Plan & Architectural Review Meeting

Monday, May 12, 2025 - 6:00 PM

Re: Site Plan Review and Certified Survey Map

Summary of Request	
Requested Approvals:	Site Plan Review and 1 Lot Certified Survey Map
Location:	1215 N Universal Boulevard (/A455700001 and /A455500003)
Current Land Use:	Lavelle Industries, Inc.
Proposed Land Use:	Lavelle Industries, Inc.
Current Zoning:	General Manufacturing District
Proposed Zoning:	N/A
Future Land Use, Comprehensive Plan:	Manufacturing

SITE PLAN &
UTILITY

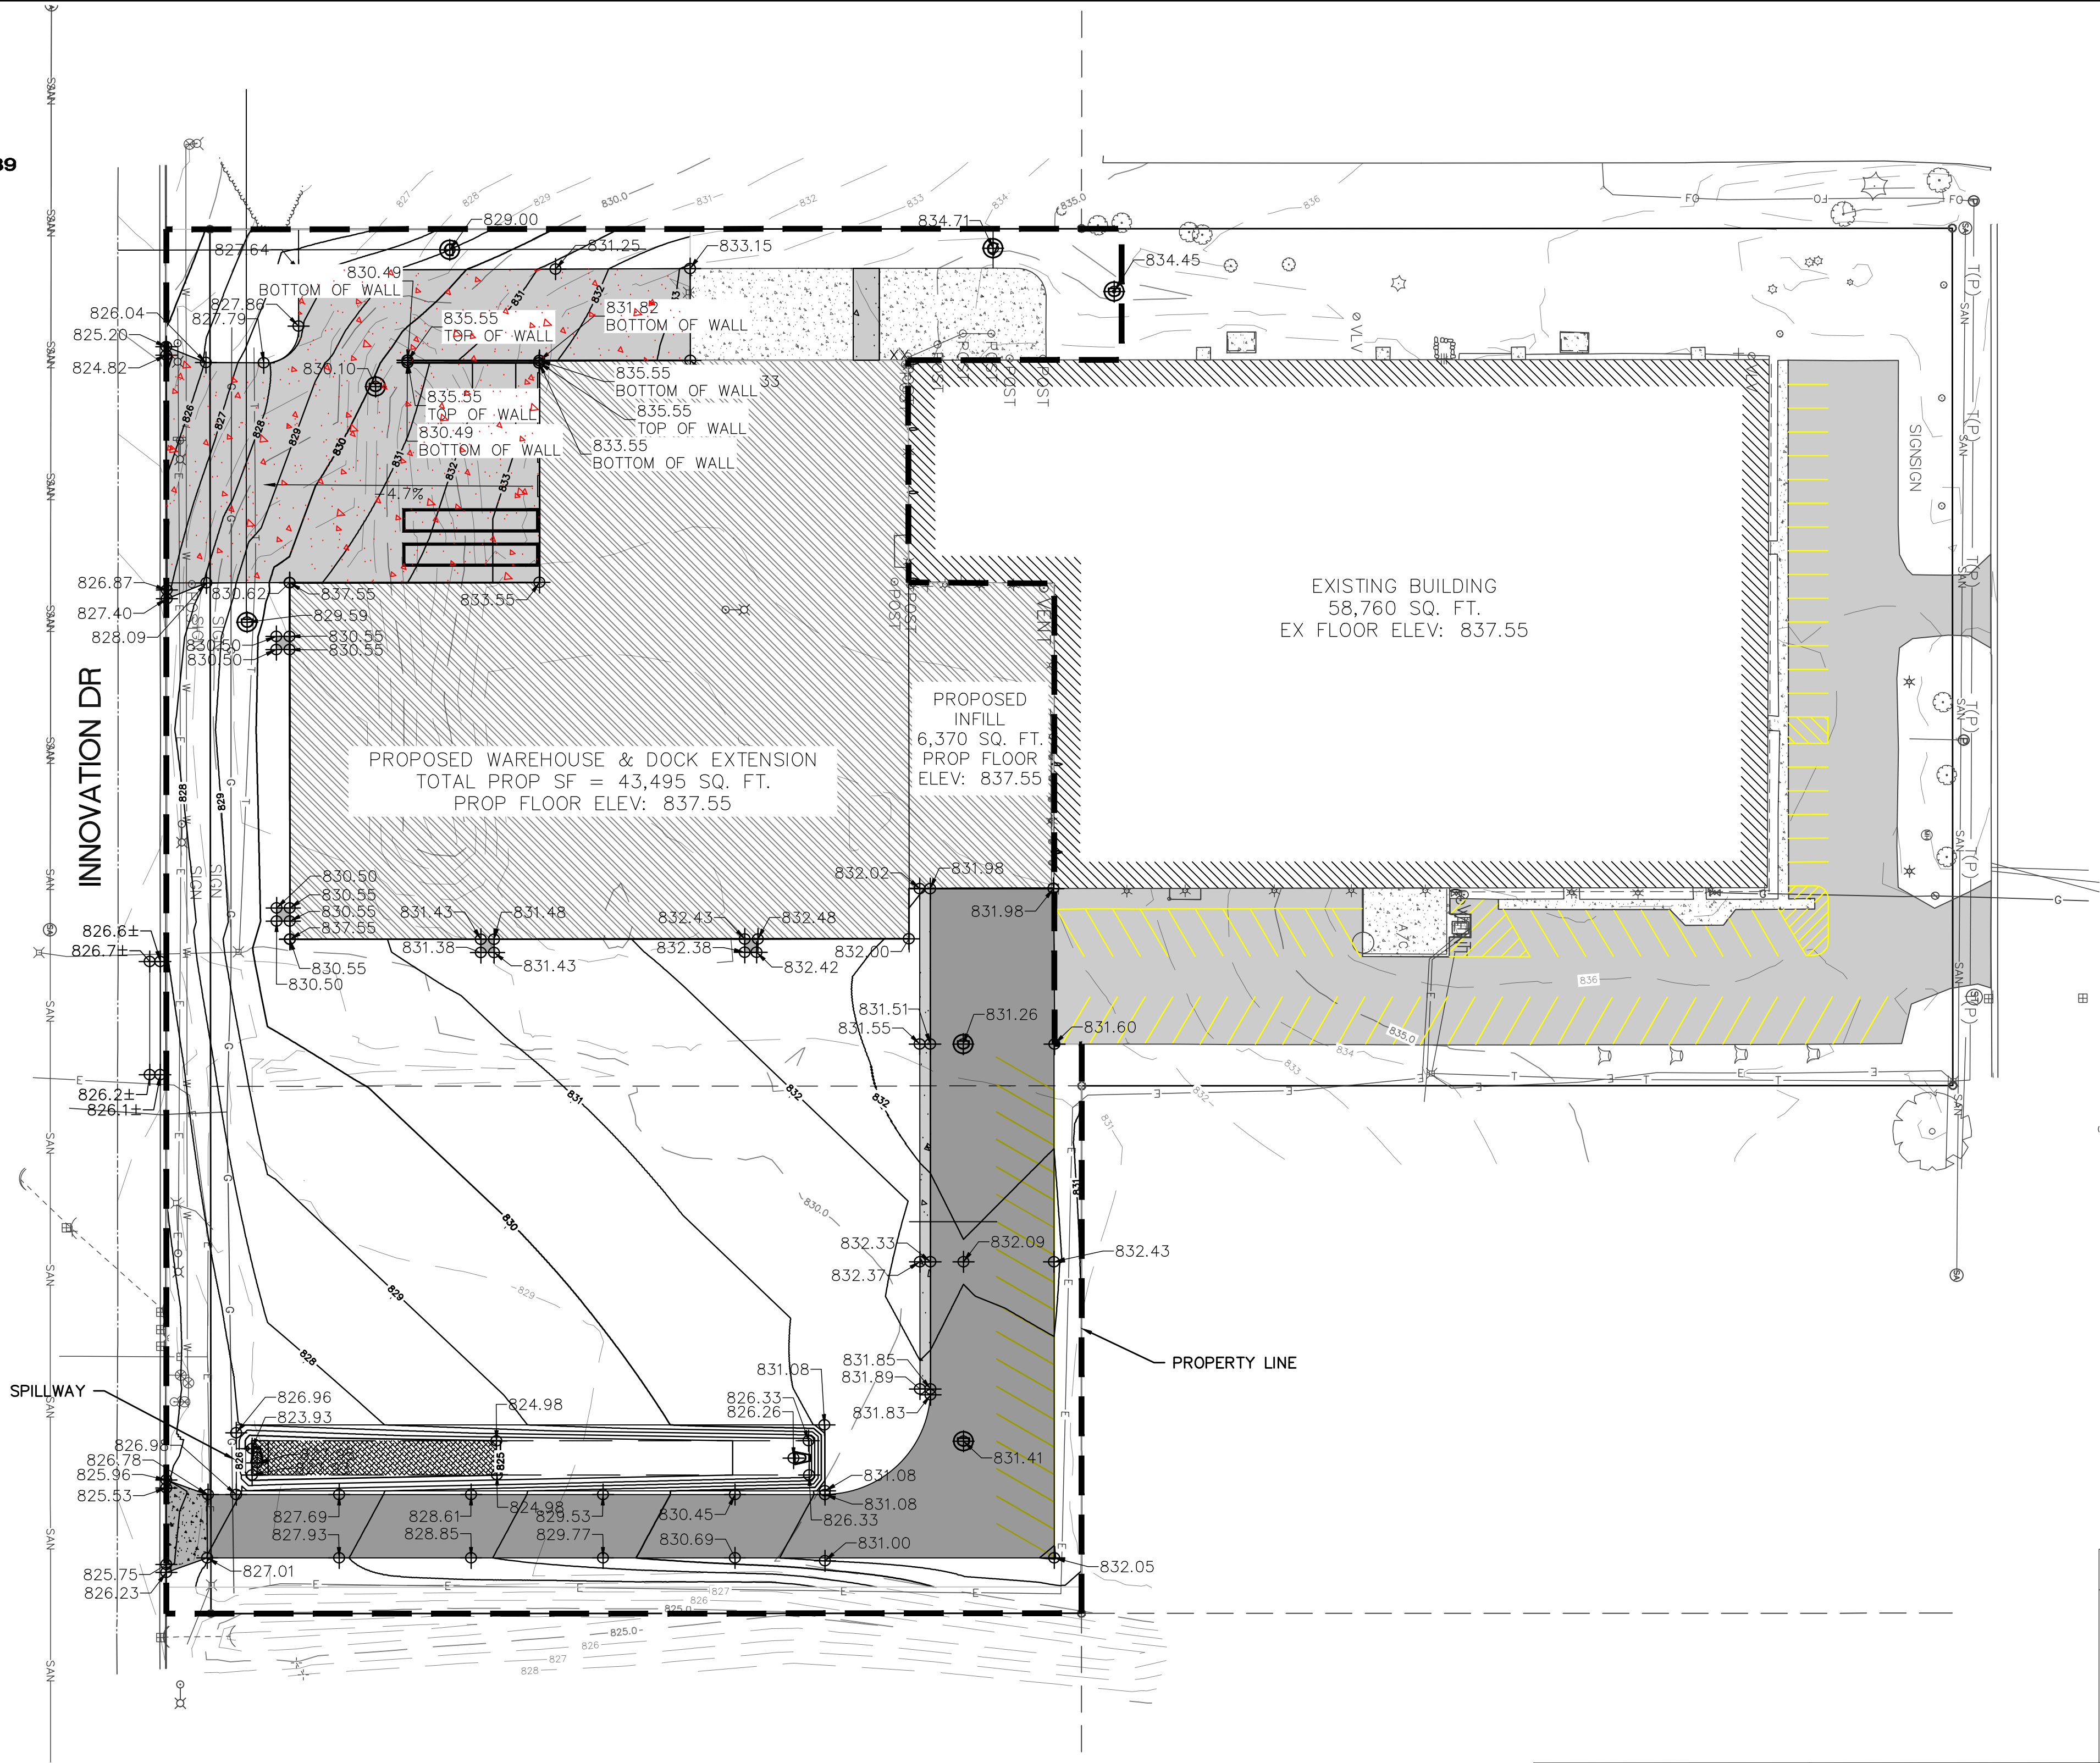
The proposed plan shows a new driveway with a width of 83.40 feet. Staff has discussed this, and is willing to approve the proposed width, as it is necessary for the semi traffic.

EAST SIDE OF PROPERTY, EAST OF DRIVEWAY

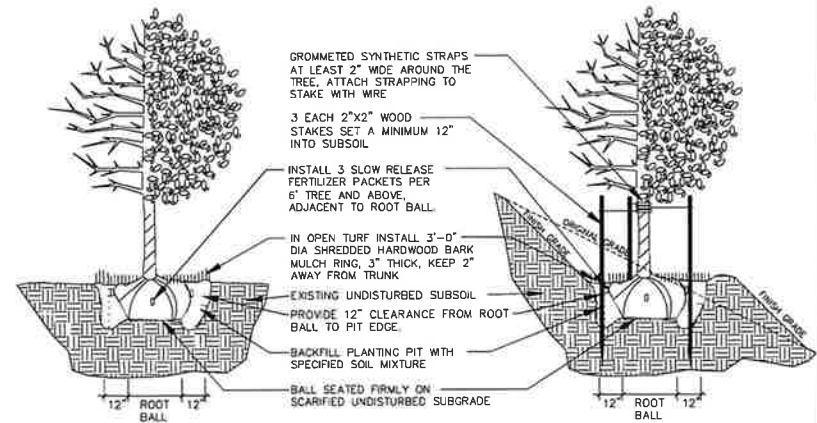
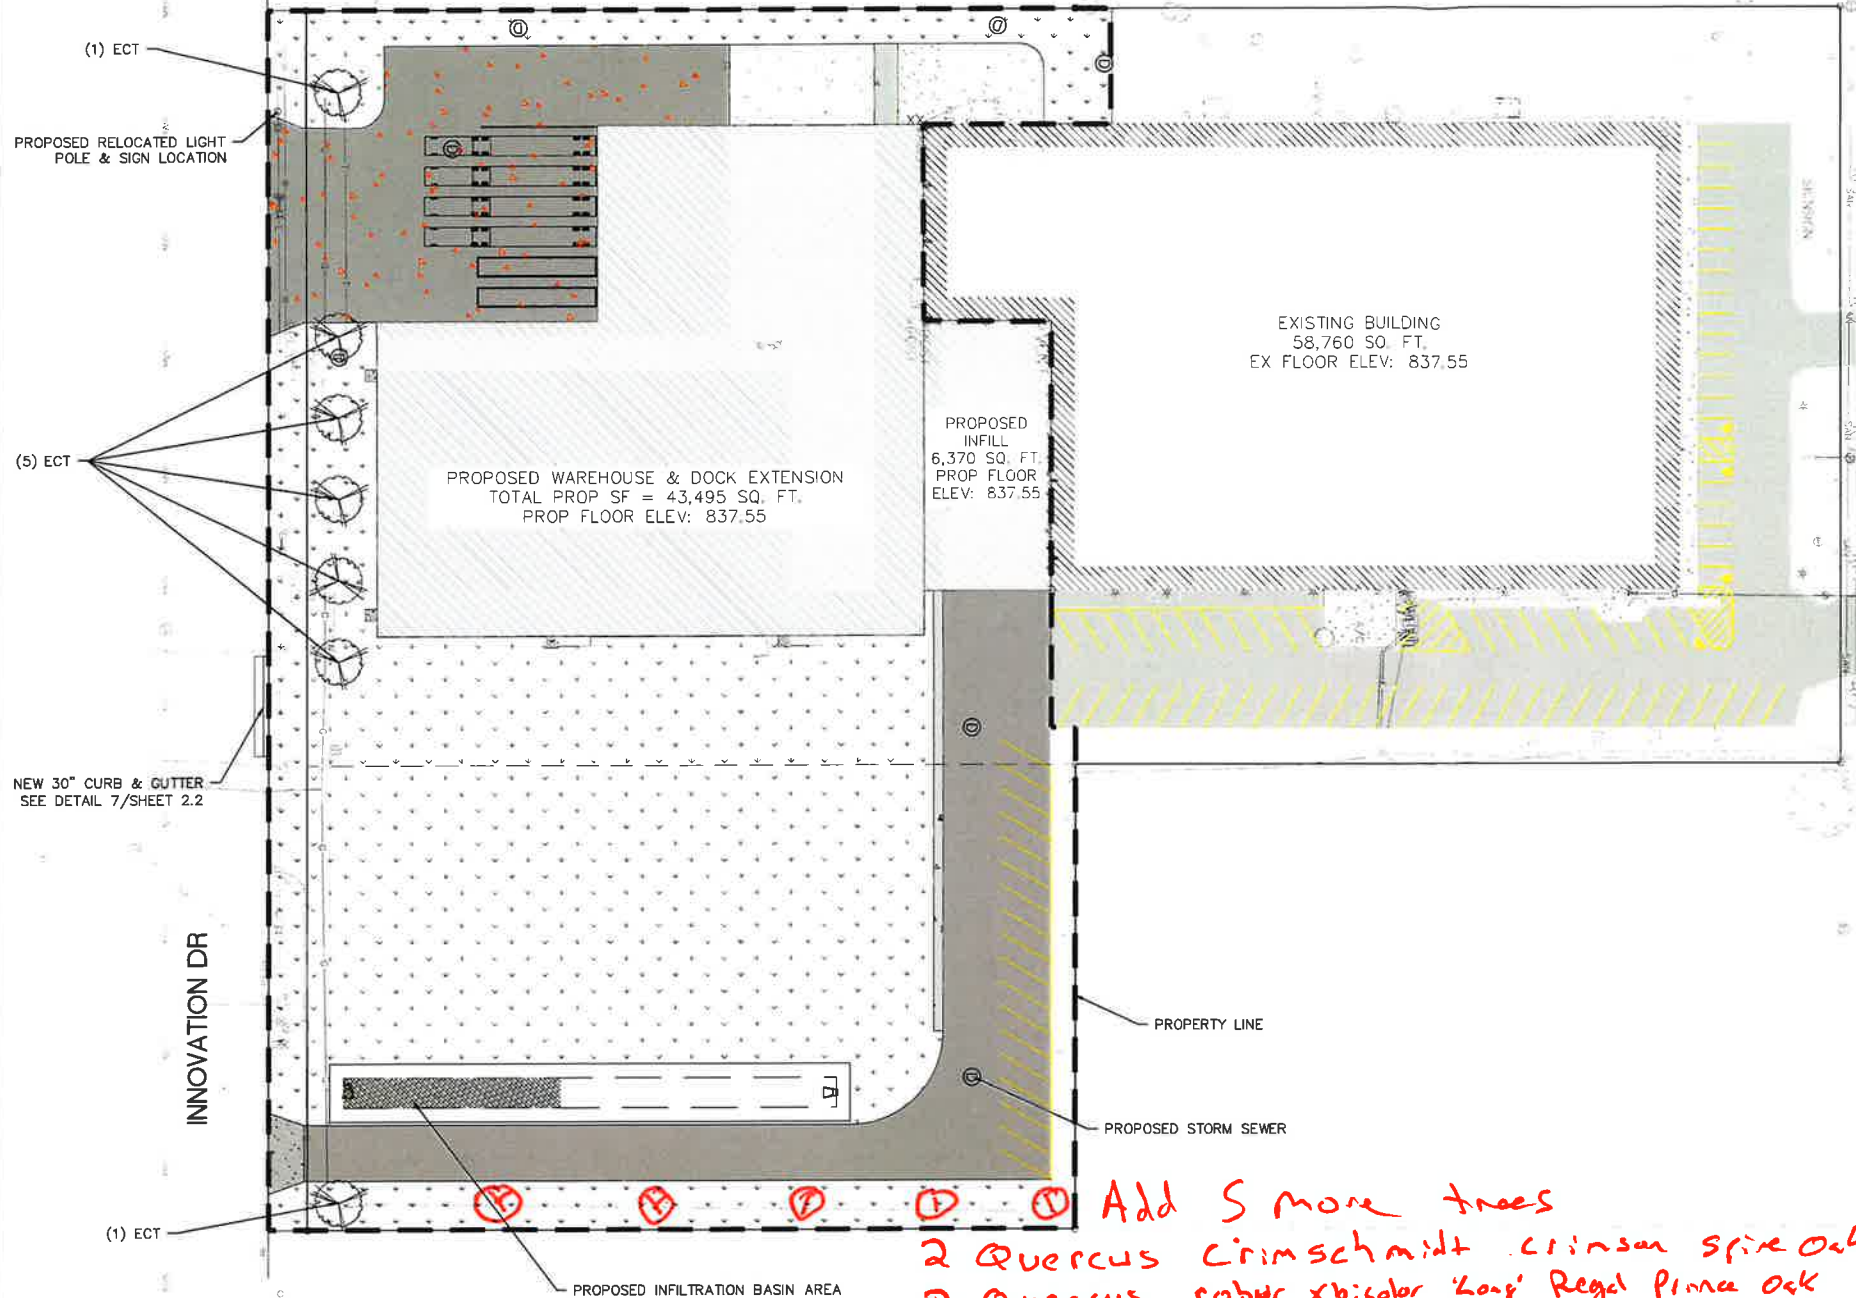
Add 5 more trees
2 Quercus crimschmidt crimson spine oak
2 Quercus robur bicolor King Regel Pinna oak
1 Ostrya virginiana Iron wood
